Date: February 8, 1996
Refer to: EM/ER:96-045

SUBJECT: RESPONSE TO THE NOTICE OF DEFICIENCY (NOD) FOR OPERABLE UNIT (OU) 1114

**Response to the Notice
of Deficiency for the
RFI Work Plan for
Operable Unit 1114,
Addendum 1**

Fig. 1. Metal catch basins at PRS C-3-016 (response to Deficiency 25).

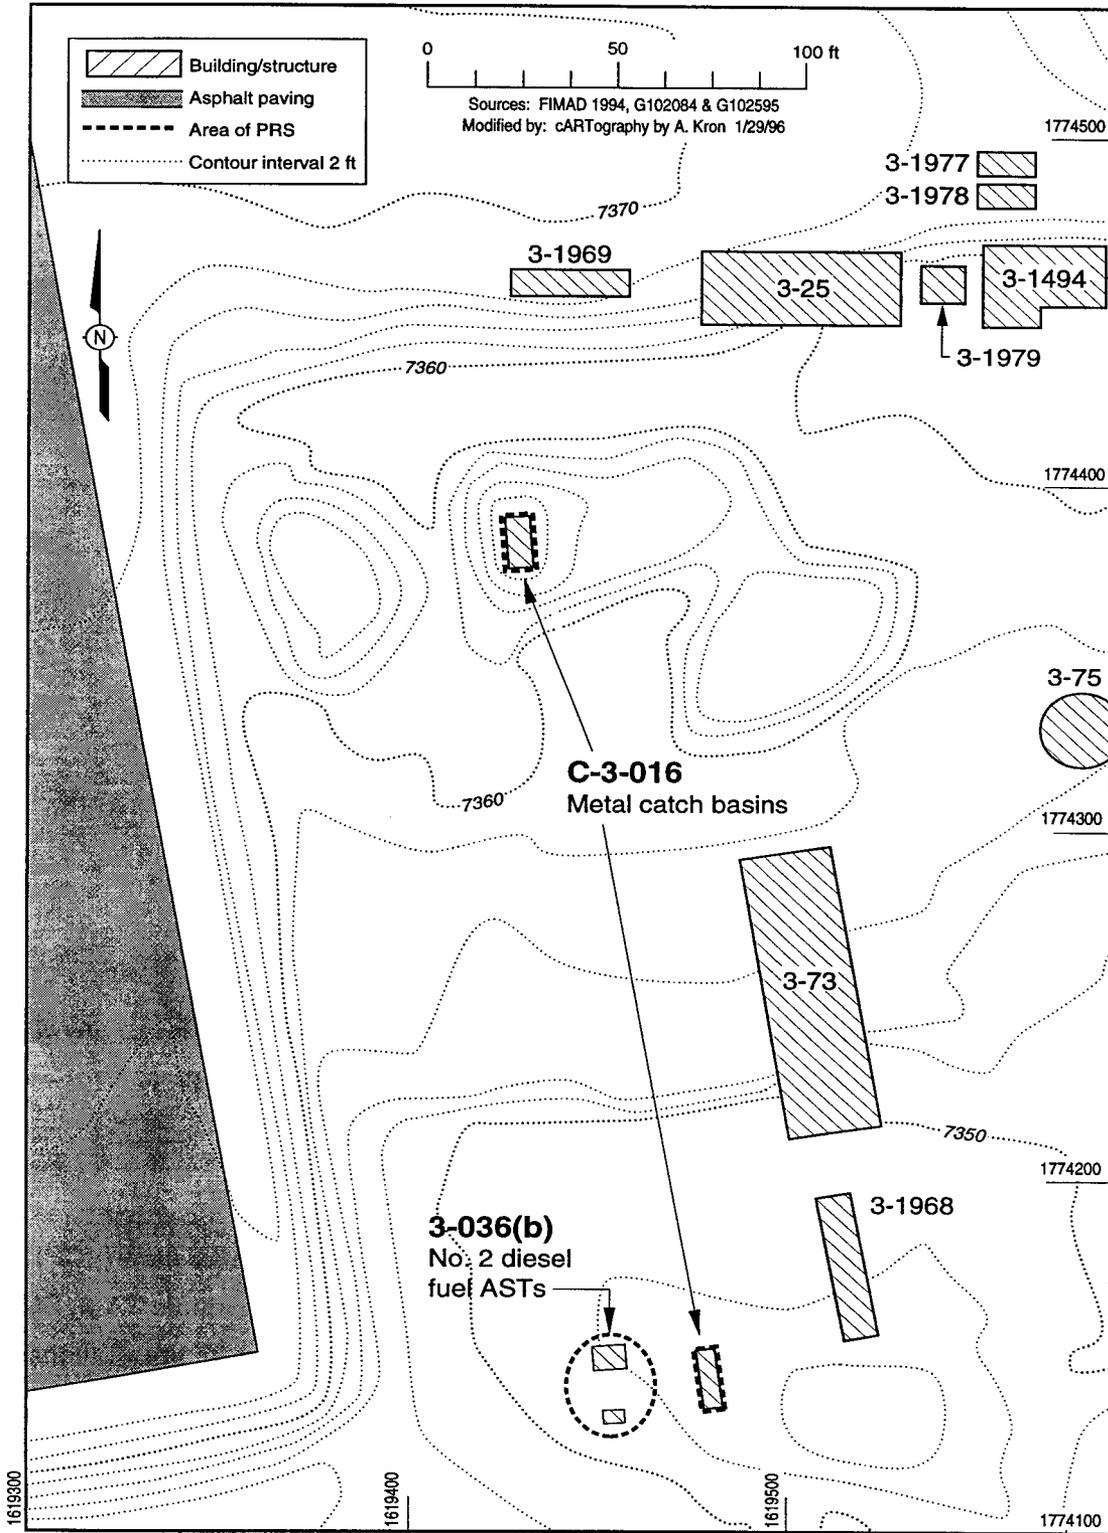
Please provide a map of this SWMU which includes the metal catch basin.

Figure 1 shows PRS 3-036(b) and the associated metal catch basins at PRS C-3-016.

ATTACHMENT 3 PHOTOS OF ASPHALT BATCH PLANT AREA

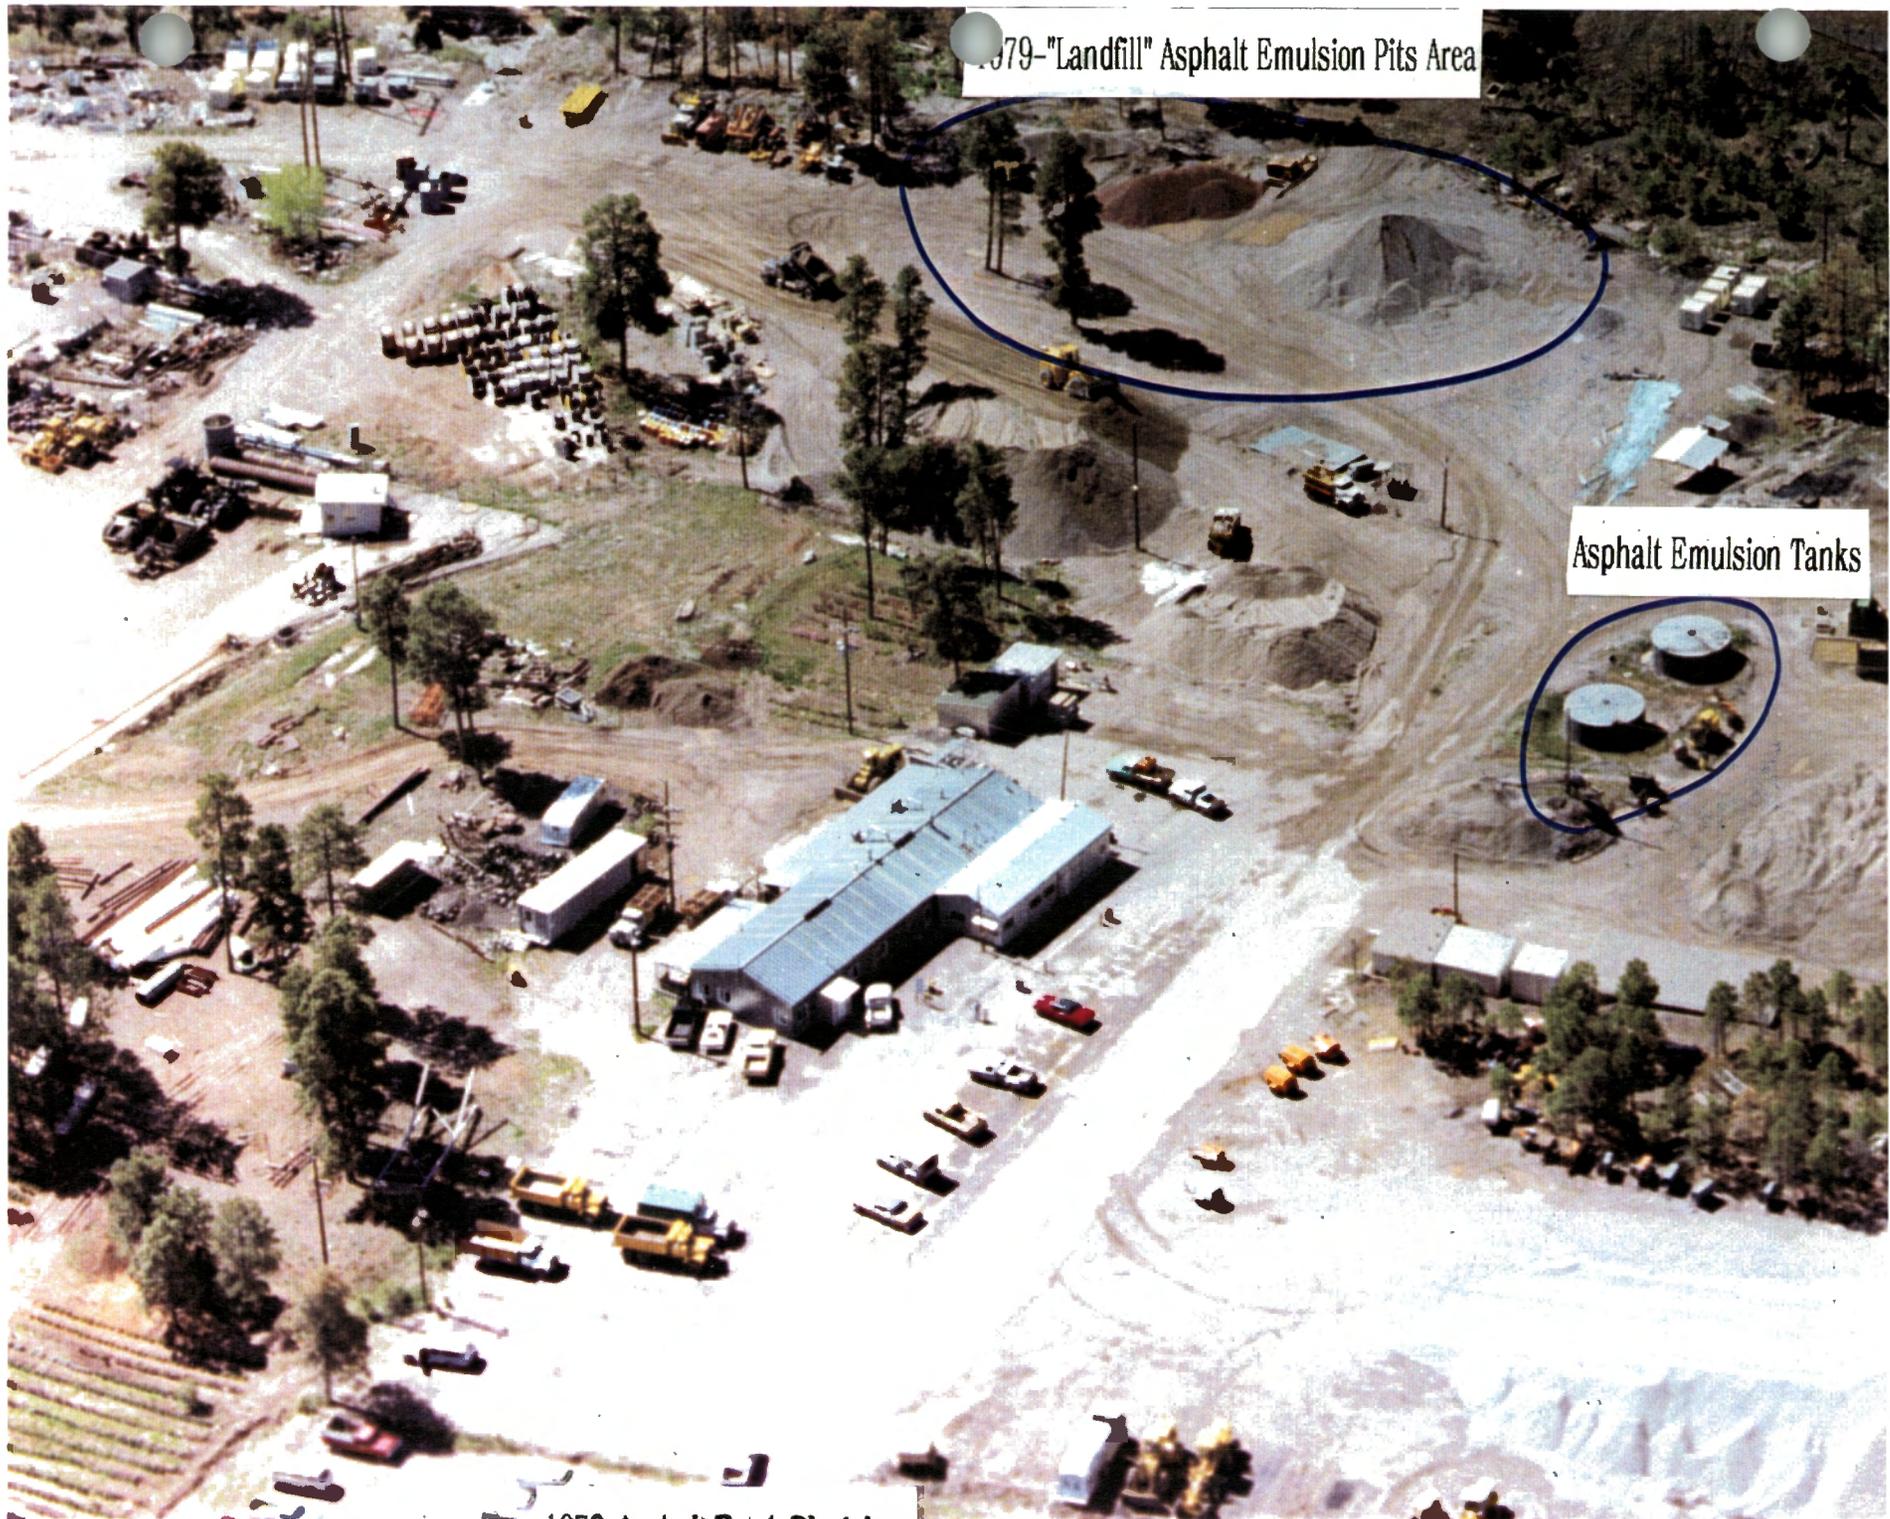
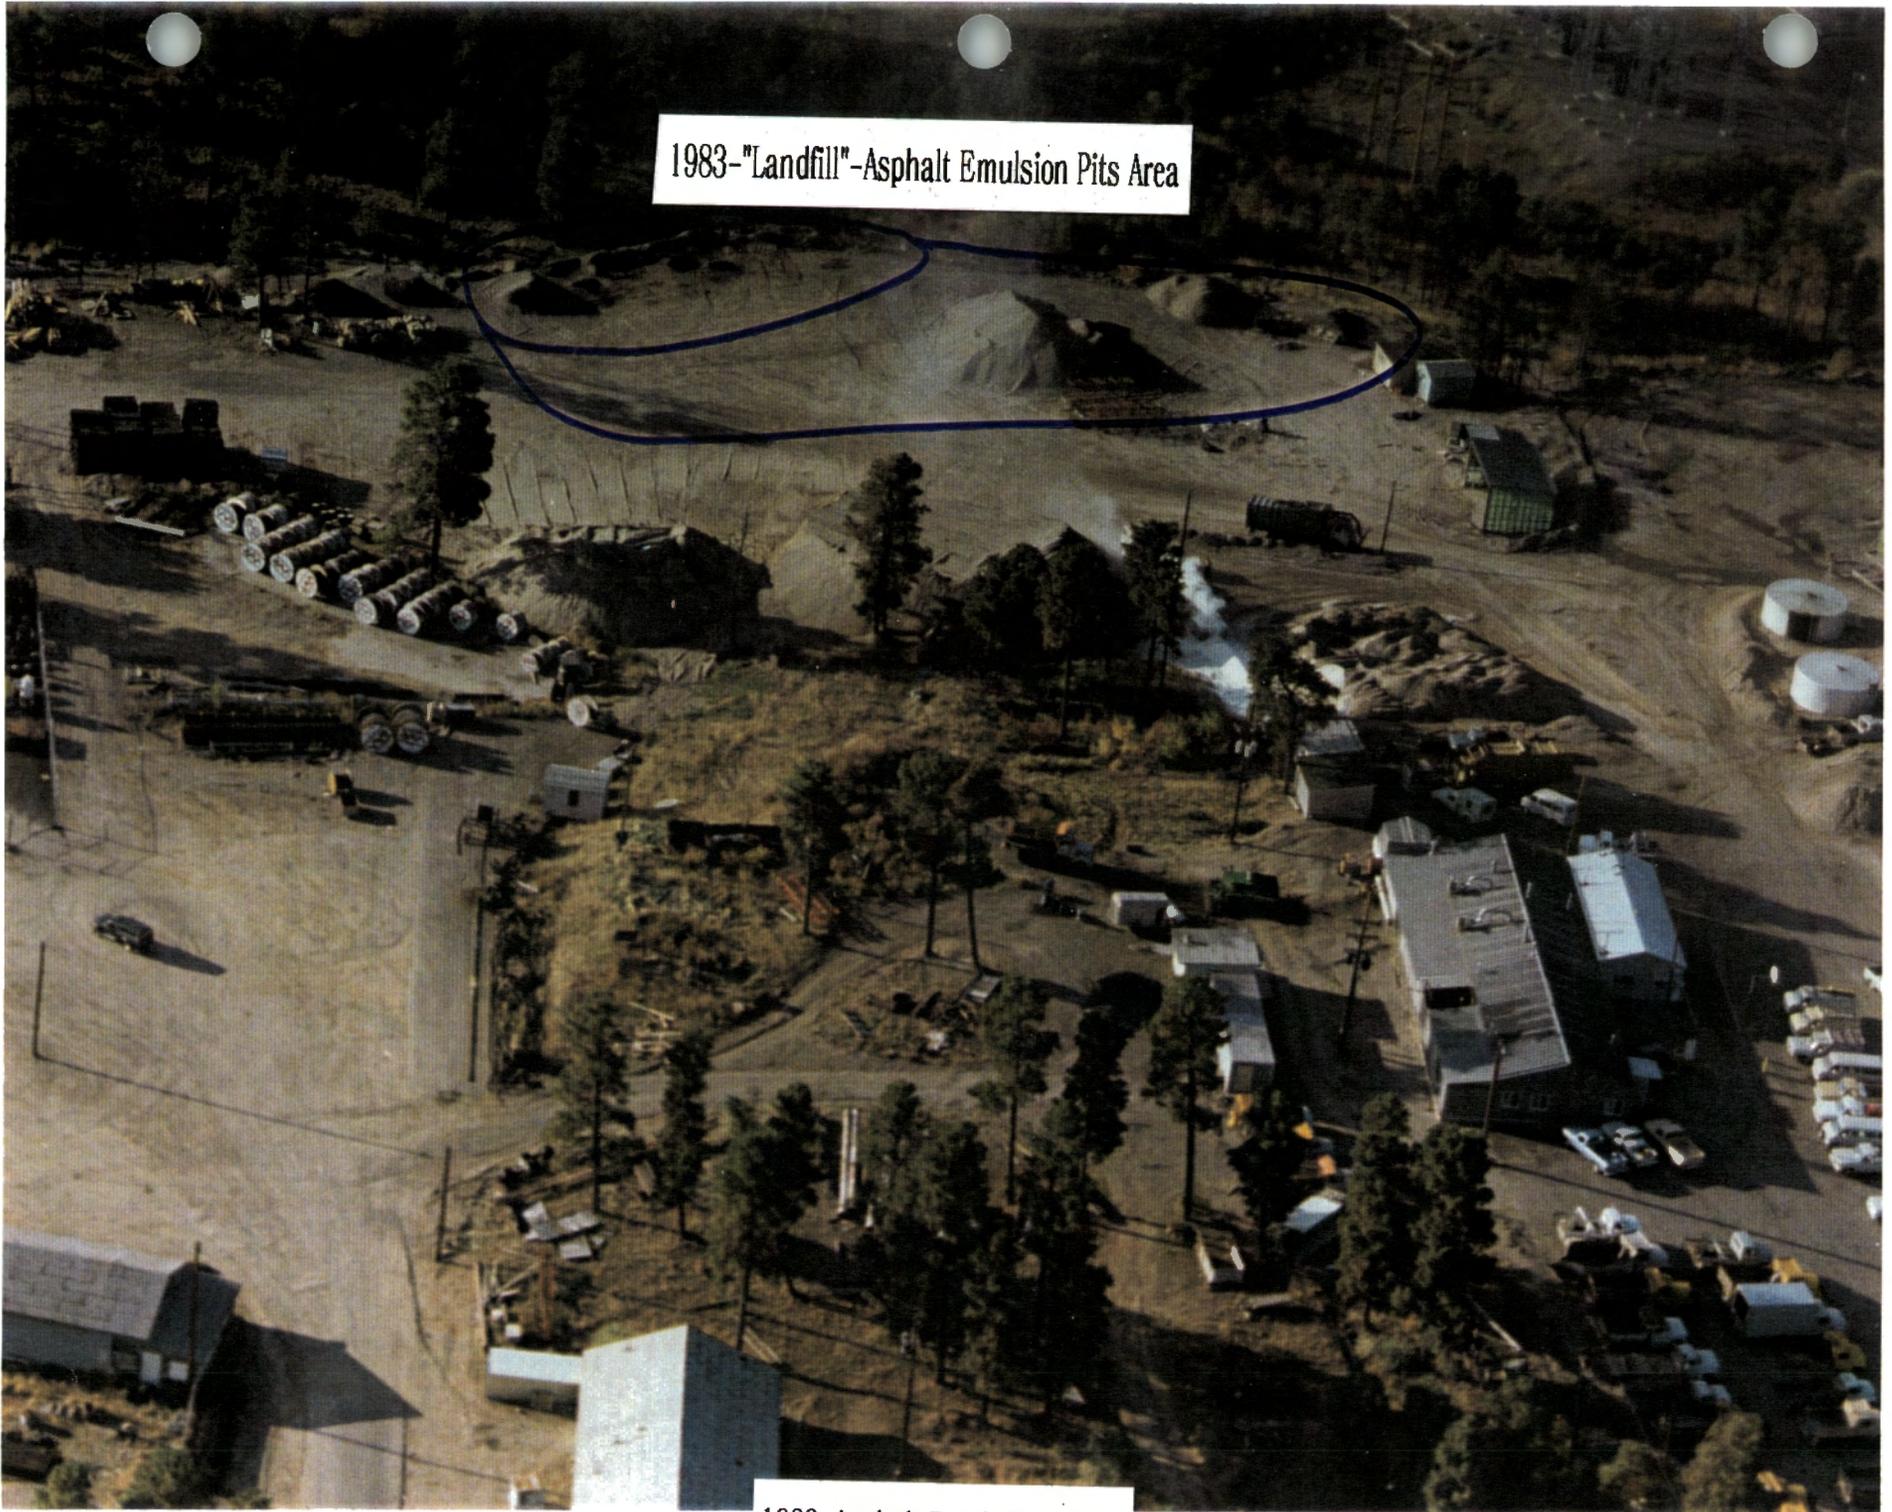
Is the landfill comprised of several pits? Please provide a map showing all the pits. EPA is also concerned with the possible vertical migration of constituents from these pits since they received tar and liquid wastes and have not been removed. Please clarify the outfall.

The pits were never mapped. However, multiple photos (1979, 1983, 1991) of the Asphalt Batch Plant with the approximate area of the pits circled are provided in Attachment 3, as well as the 3-045(g) outfall location, circled for clarification.

**PHOTO OF LOCKED OUTFALL GATE AT ASPHALT BATCH PLANT
SWMU 3-045(g)**

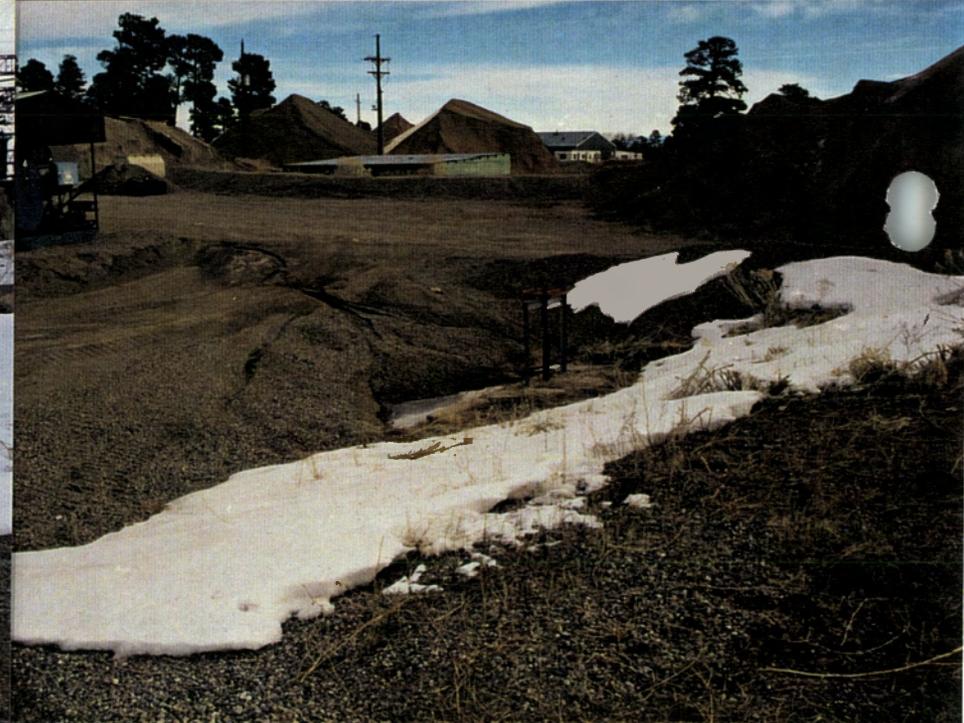
Please include a map of this SWMU in the revised work plan. EPA disagrees with no further action on this SWMU since soil sampling has never been performed.

A photo of the drainage culvert (EPA outfall 04A109) that was closed up is provided in Attachment 3. The photo reveals that the soil surrounding the culvert to the north is recessed and adjacent to aggregate and sand piles, which may contain small quantities of equipment oil, hydraulic fluid, diesel fuel, and small quantities of fluids that may originate from operational releases during the normal daily activities at the plant. It will be very difficult to ascertain extent of contamination (assuming contamination is detected) from this SWMU because of the continued disturbance of soil, sand, and aggregate around this culvert during the daily operations of the Asphalt Batch Plant. In addition, polycyclic aromatic hydrocarbons (PAHs) will be ubiquitous COPCs at this site because they are inherent in asphalt. Therefore, LANL recommends that any sampling performed at this SWMU be deferred to after decontamination and decommissioning (D & D). There is no current schedule for D & D at the Asphalt Batch Plant.
